Ground Water Review Form:

Application: T-13104

Applicant Name: Monte Heid

Reviewer(s): Phillip I. Marcy

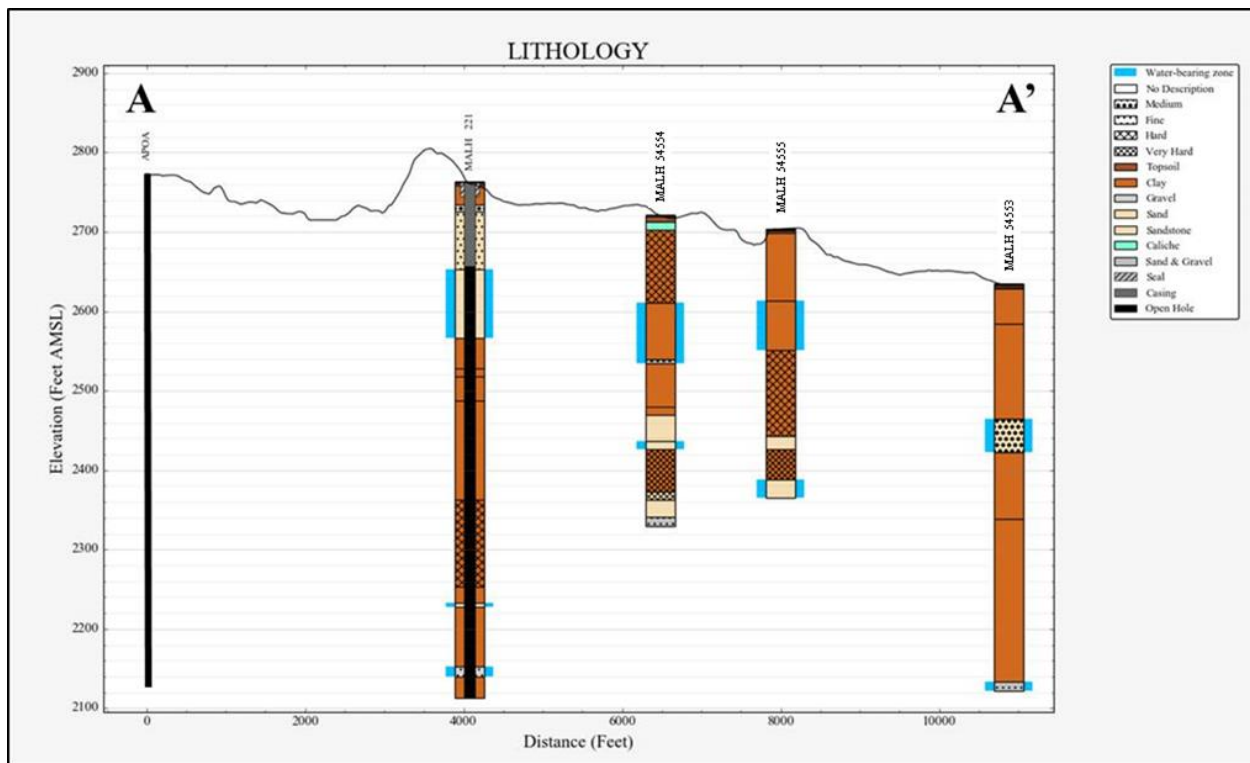
4. a) Will this proposed change, at its maximum allowed rate of use, likely result in an increase in interference with **another ground water right**?
 Yes No Comments: The proposed POA location places it closer to POA well 3 under permit G-13533, owned by Sagebrush Farms, LLC (2,150' versus 3,420' at the closest authorized POA location).

Yes No If yes, explain: The change in distance to the nearest neighboring POA is not expected to significantly affect groundwater availability at that location.

Yes No Comments: The proposed POA location is not significantly closer to any perennial surface water source.

Provide context for minimal/significant impact: Gum Creek is a seasonal drainage that only flows during snowmelt periods in the spring.

The applicant's authorized POA wells all produce from alluvium, predominantly from sand and gravel horizons in a thick section of fine-grained clay and tuffaceous siltstone. The proposed APOA well will likely be constructed similarly to MALH 221. See attached map for well locations.
